ADDENDUM NUMBER: Addendum - One

PROJECT TITLE: Milwaukee County Health & Human Services
Marcia P. Coggs Building
Roof Replacement
Site Number: 340
Building Number: 5600
1220 West Vliet Street
Milwaukee, WI. 53205

PROJECT NUMBER: S035-10429

DATE OF ADDENDUM: July 12, 2011

REVISED
4 FLASHING @ PLATFORM SUPPORT
R5 3"=1'-0"

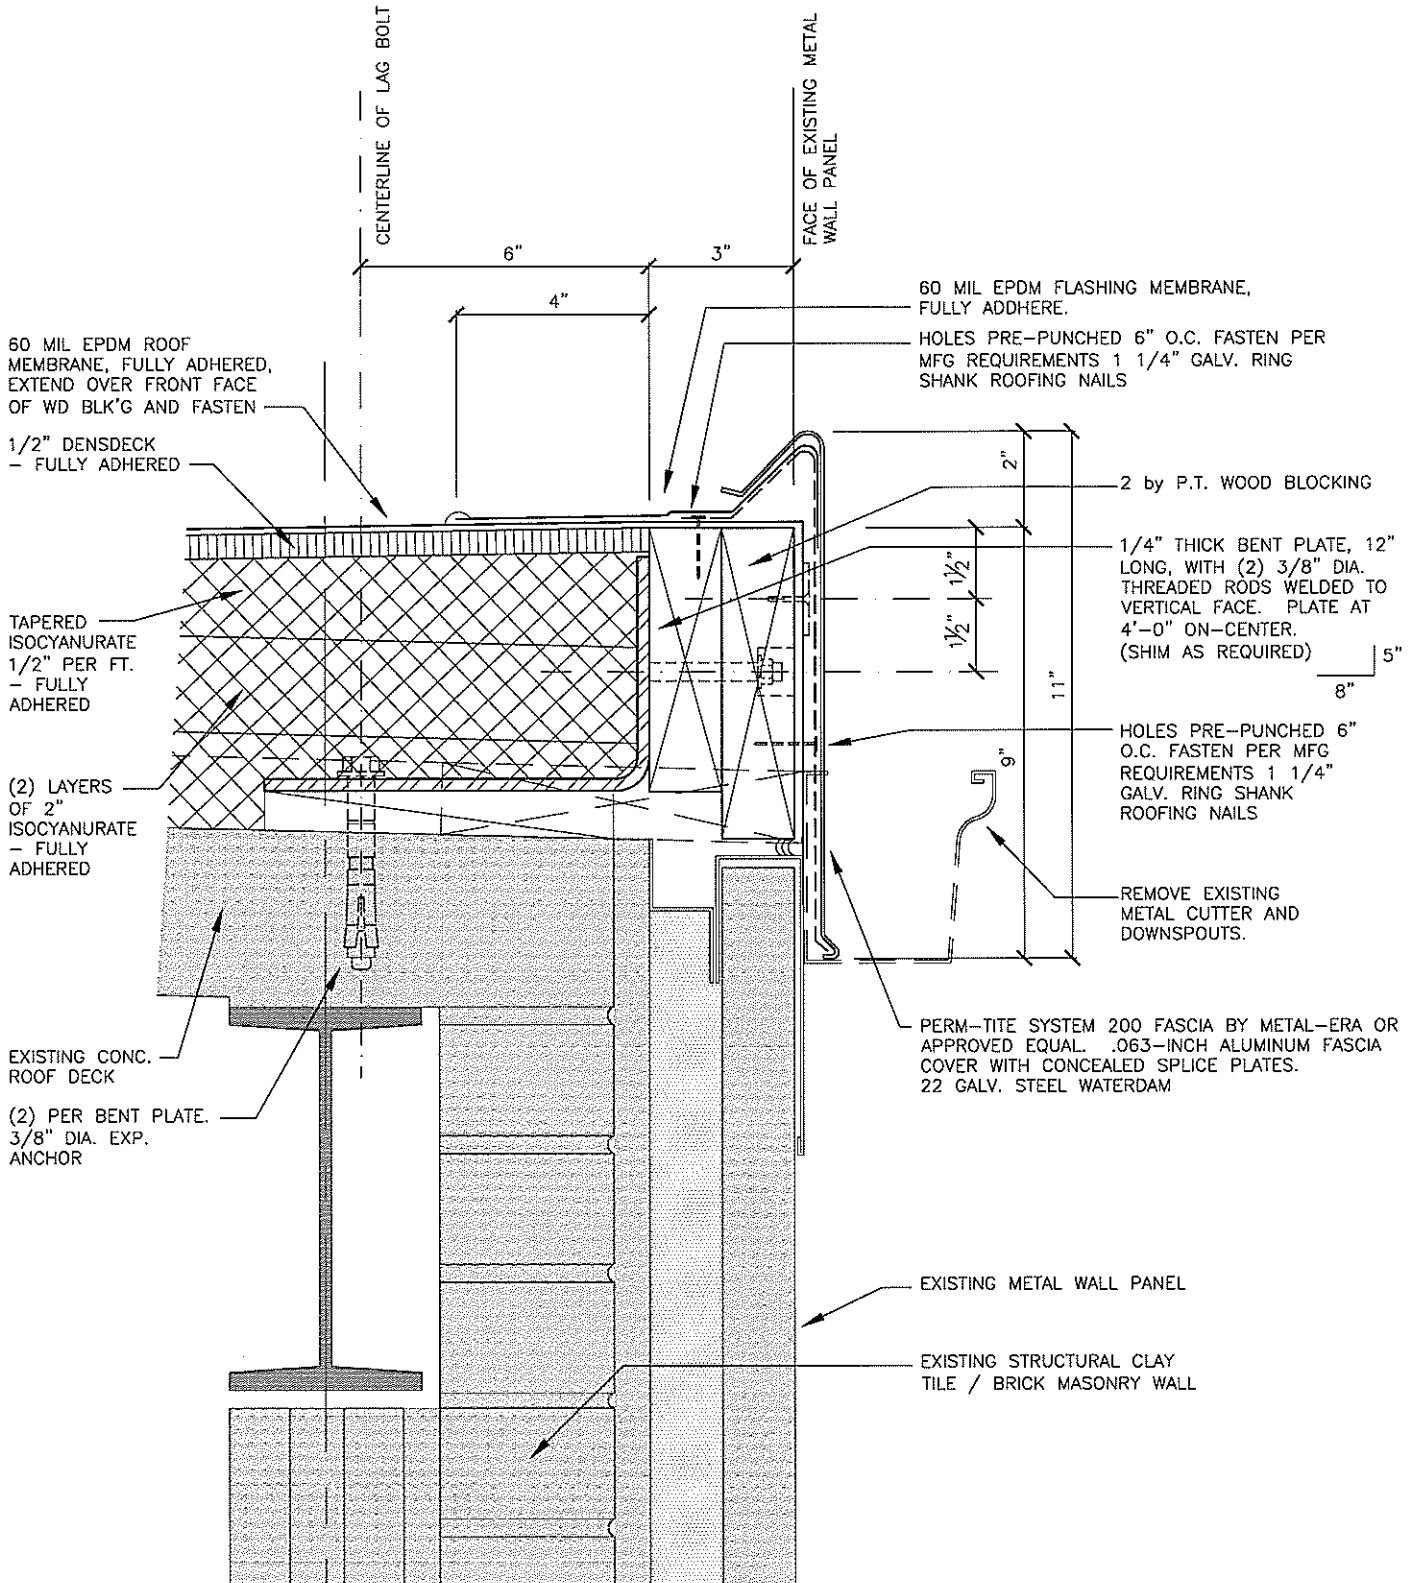
Sheet Number R5, Detail 4 / R5:

Revise Detail 4 / R5 in its entirety to attached Addendum One detail on Sheet AD-1b.

REVISED
FLASHING @ PLATFORM SUPPORT
2
R5 3"=1'-0"

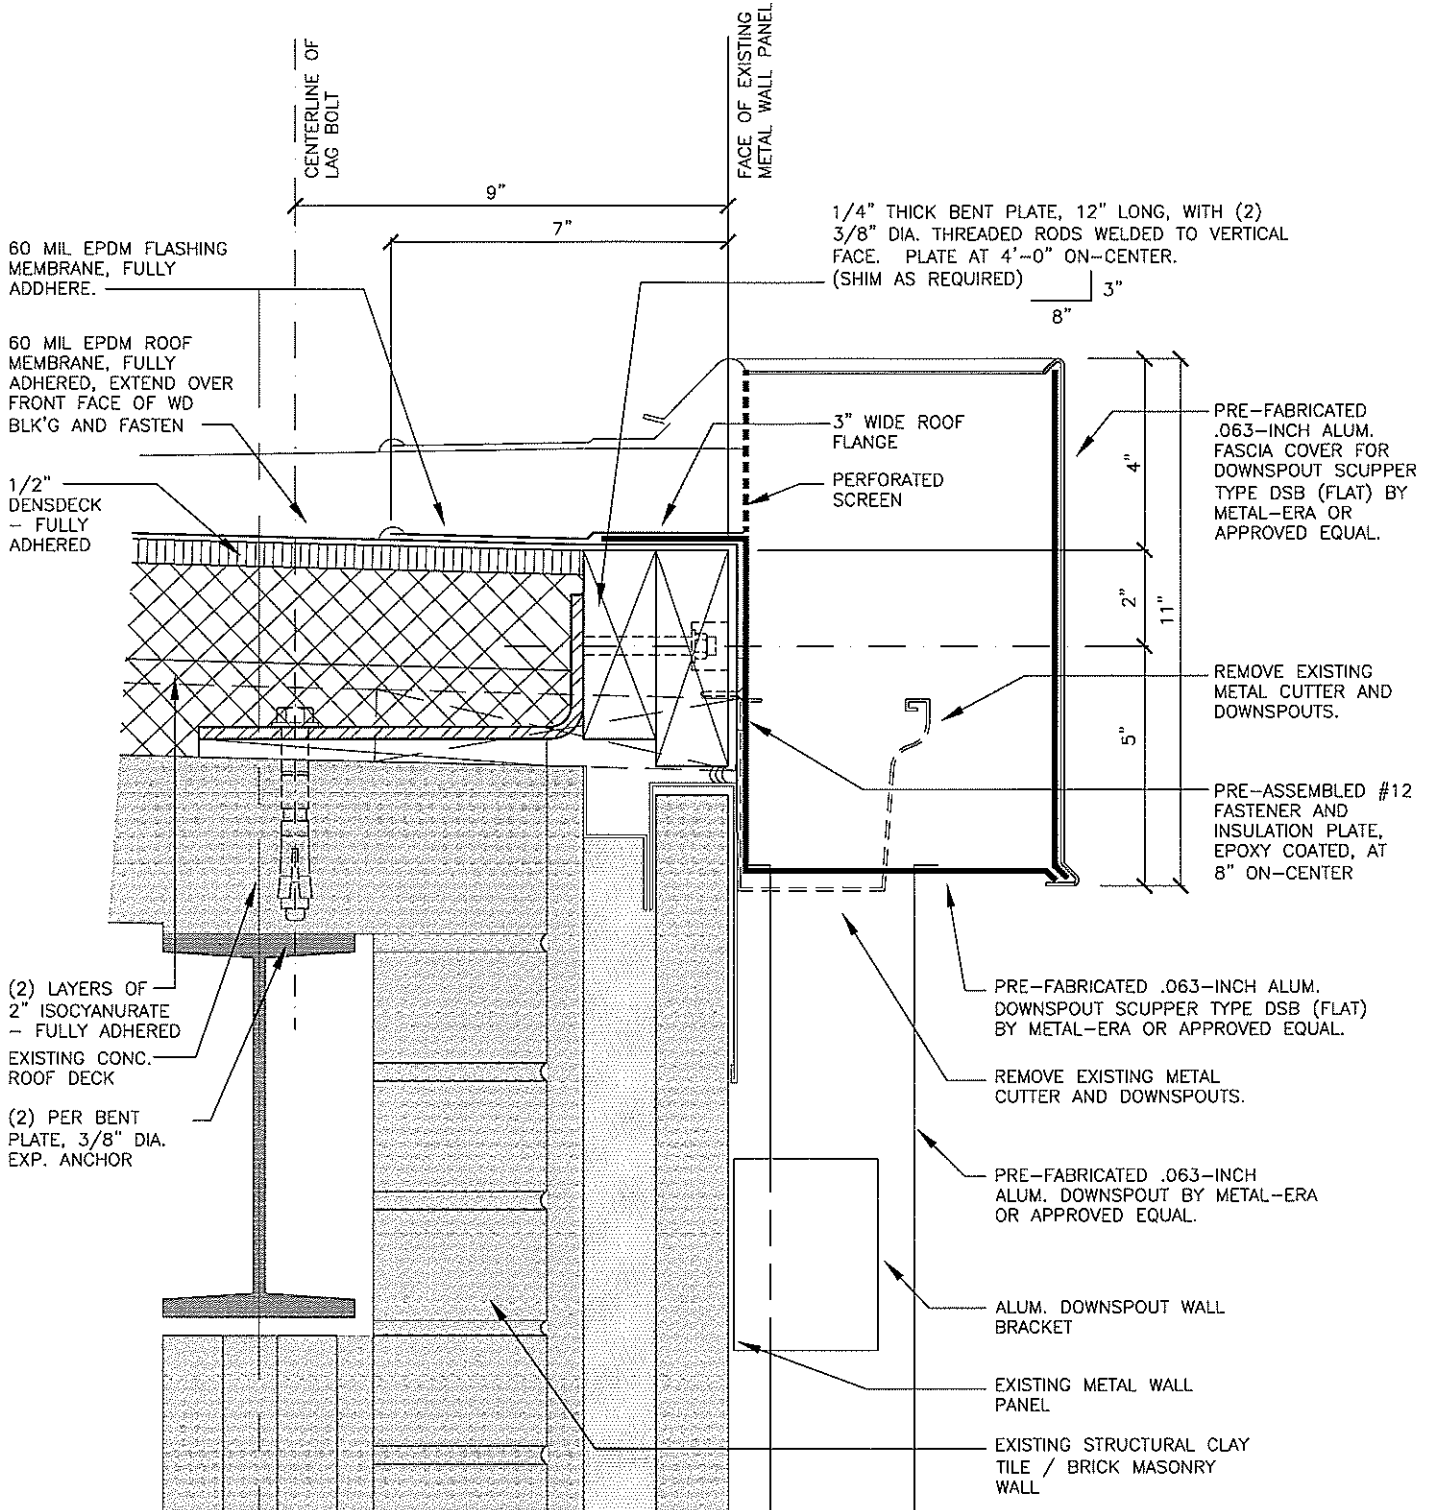
Sheet Number R5, Detail 2 / R5:

Revise Detail 2 / R5 in its entirety to attached Addendum One detail on Sheet AD-1c.

REVISED
1 ROOF EDGE/WALL
R6 3"=1'-0"

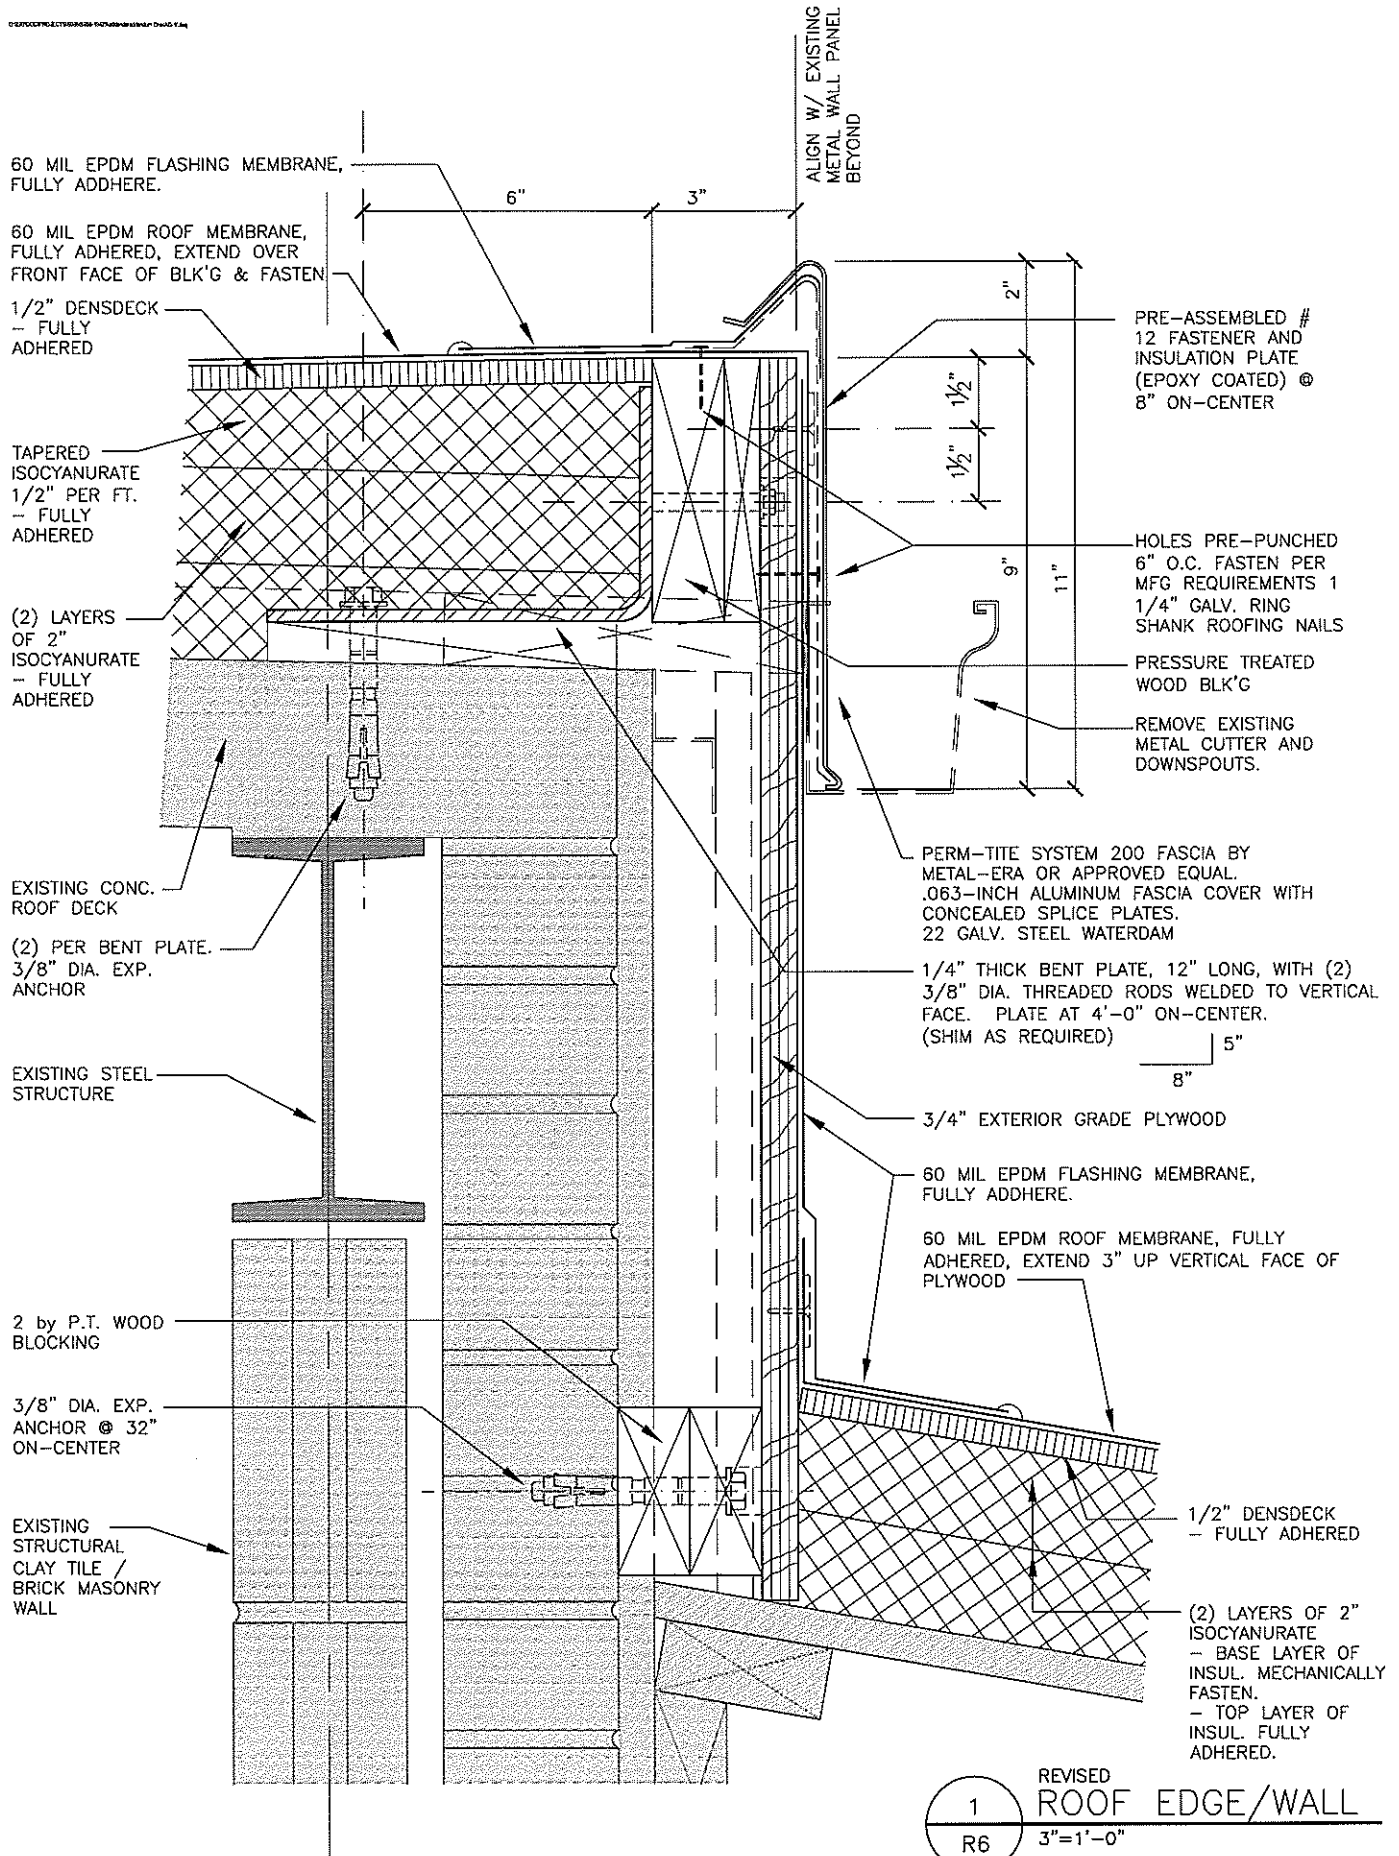
Sheet Number R6, Detail 1 / R6:

Revise Detail 1 / R6 in its entirety to attached Addendum One detail on Sheet AD-1f.

REVISED
2 ROOF EDGE
R6 3"=1'-0"

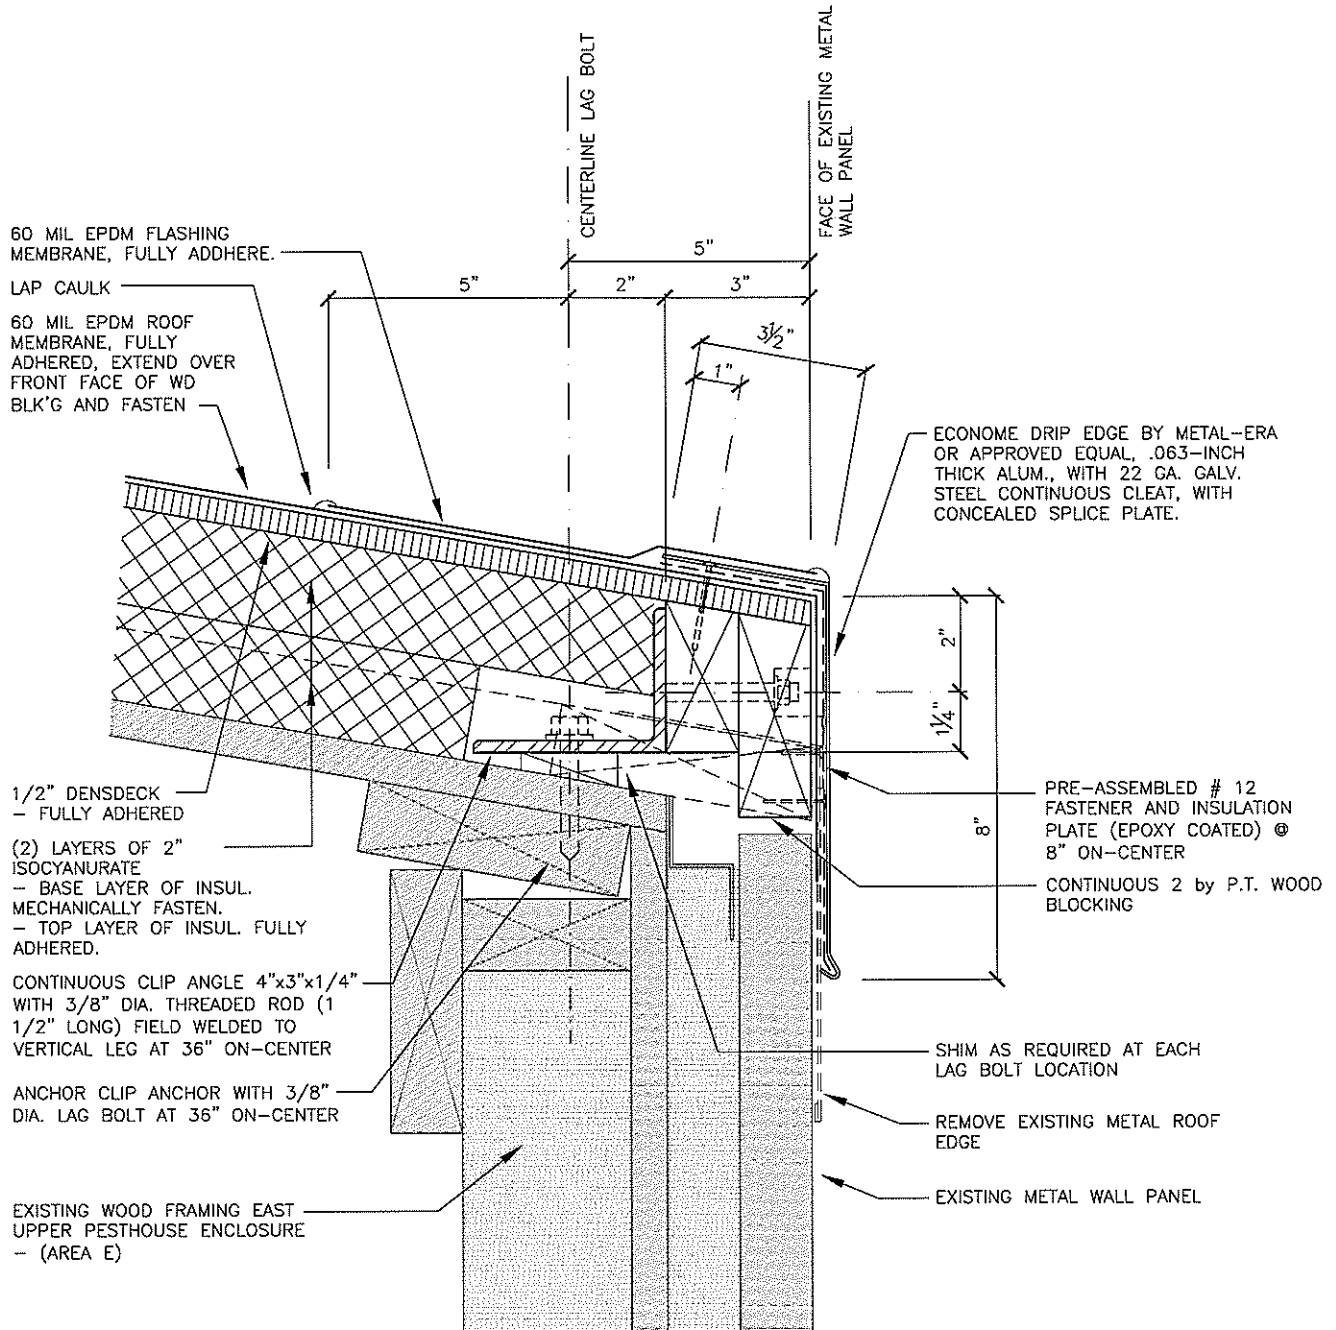
Sheet Number R6, Detail 2 / R6:

Revise Detail 2 / R6 in its entirety to attached Addendum One detail on Sheet AD-1g.
